ISSUE/REVISION:		
REV.	DATE	DESCRIPTION
1	10/03/2023	ISSUED FOR BID
1	10/18/2023	ADDENDUM 1

PROJECT:
GUARANTEED RATE FIELD -
FIRE ALARM REPLACEMENT

DRAWING TITLE:
ELECTRICAL FIRE ALARM NEW
WORK PLAN - SERVICE LEVEL
- SECTION 6

1 ELECTRICAL FIRE ALARM NEW WORK PLAN - MAIN CONCOURSE LEVEL - 320 W 35TH - SECTION 2

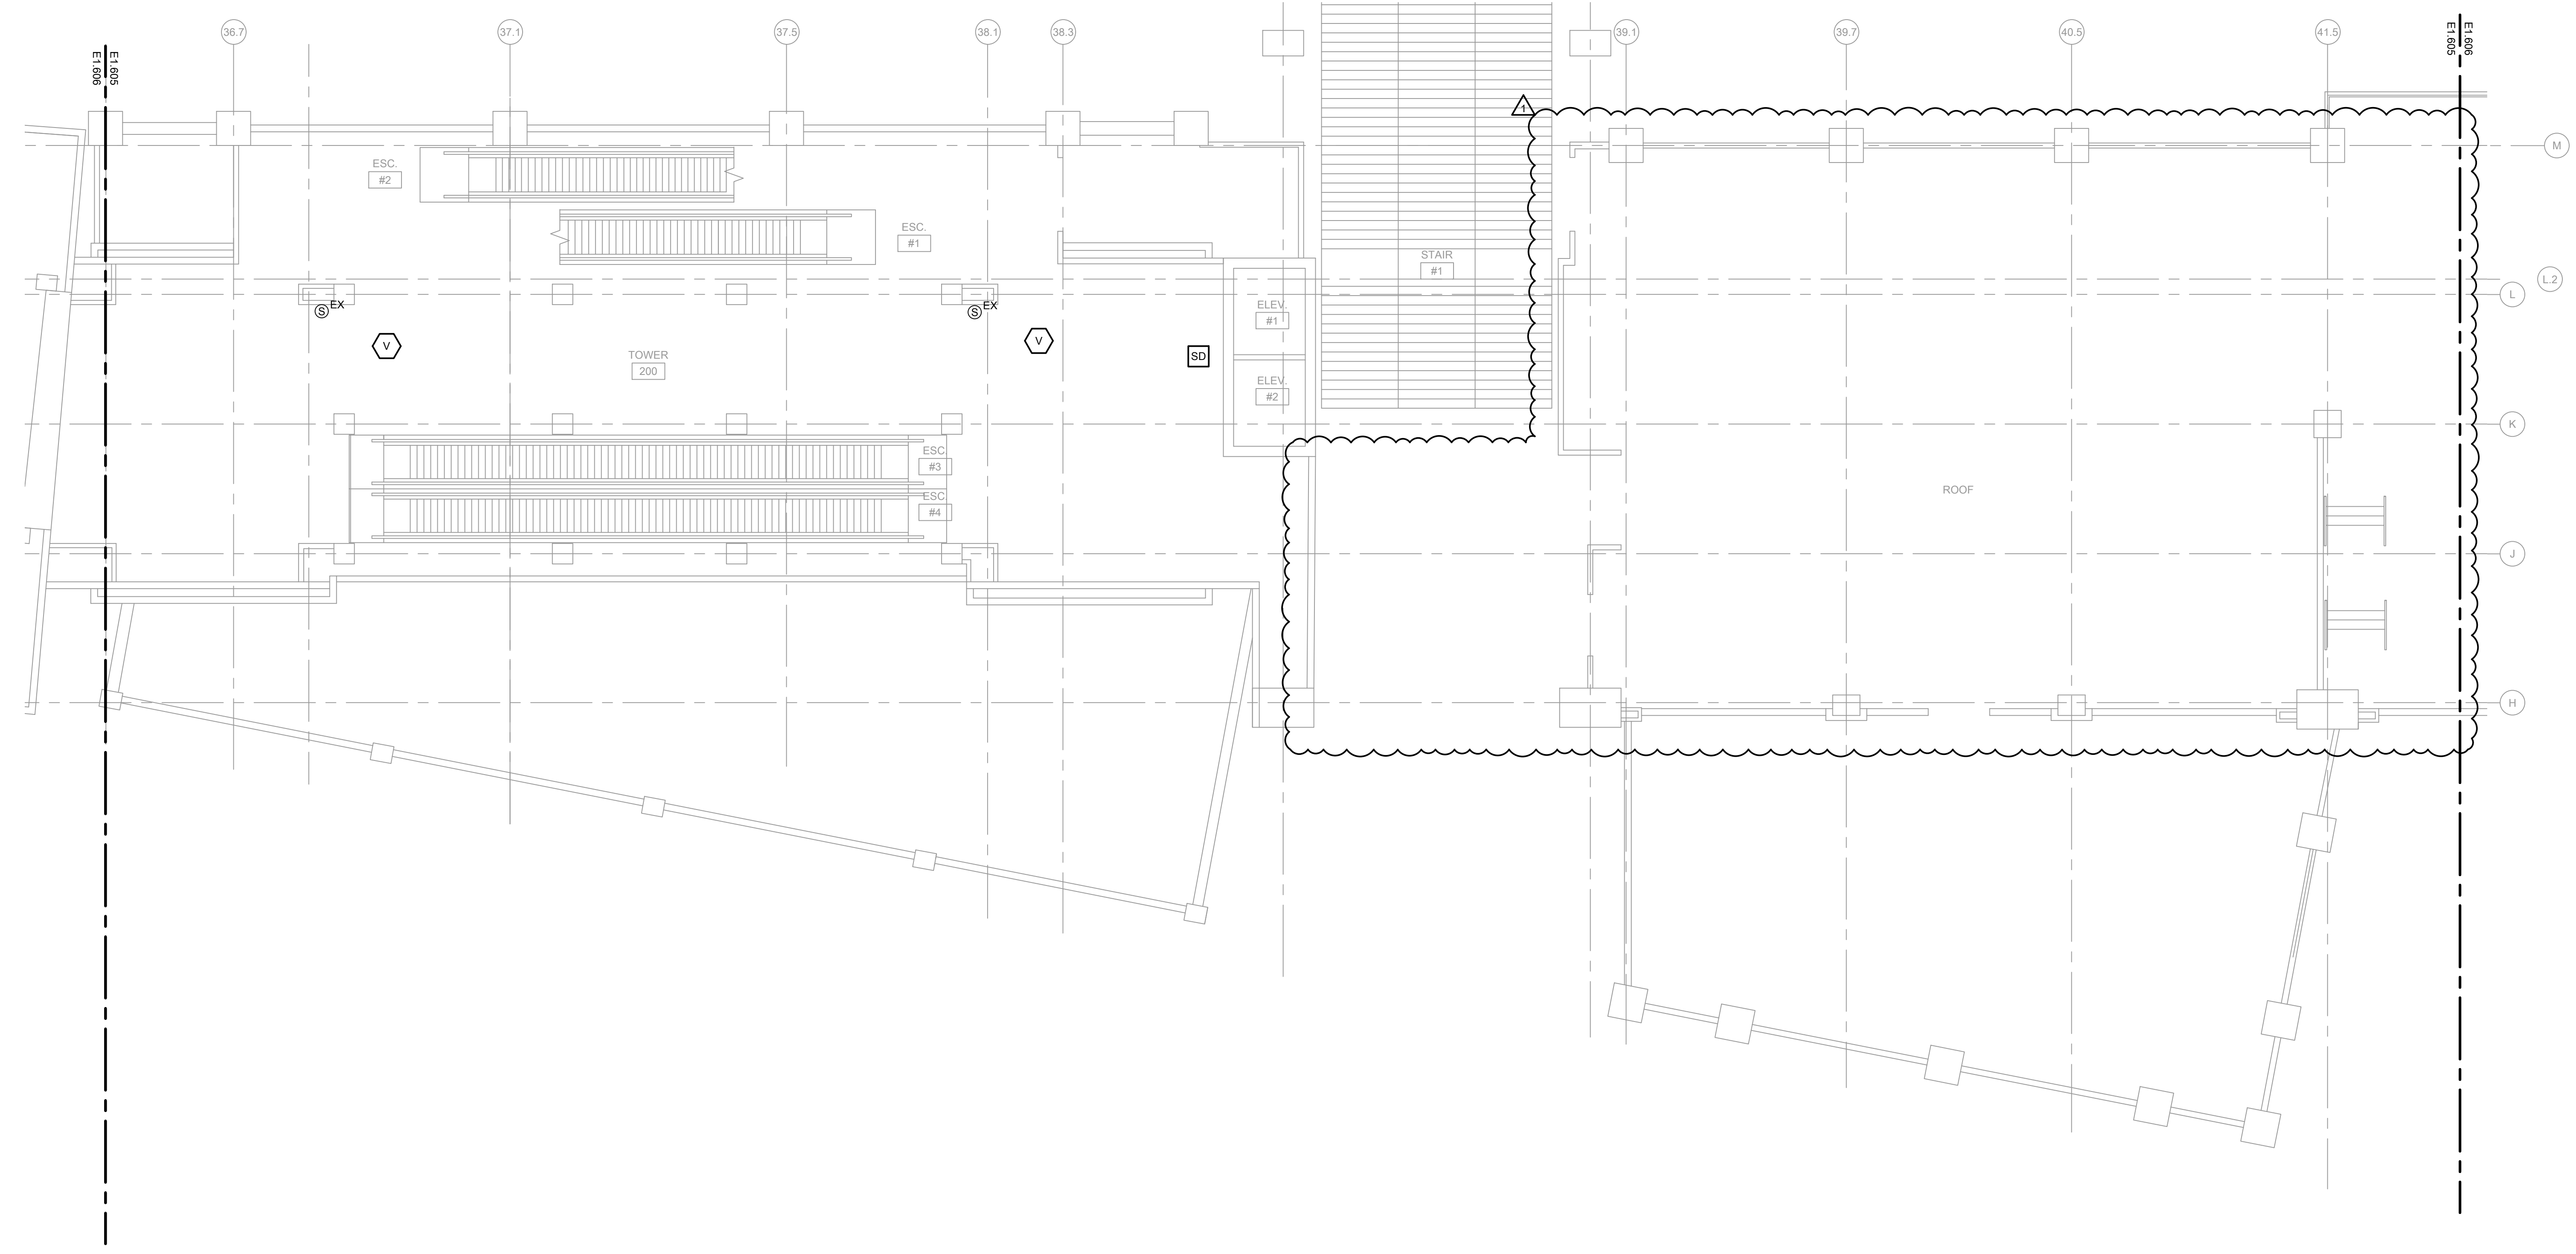
A2. ALTERNATE 2: FURNISH AND INSTALL WEATHER PROOF VISUAL FIRE ALARM DEVICE. FURNISH AND INSTALL NEW WIRING AND CONDUIT AS REQUIRED. CONTRACTOR TO DETERMINE BEST MOUNTING LOCATION BASED ON FIELD CONDITIONS.
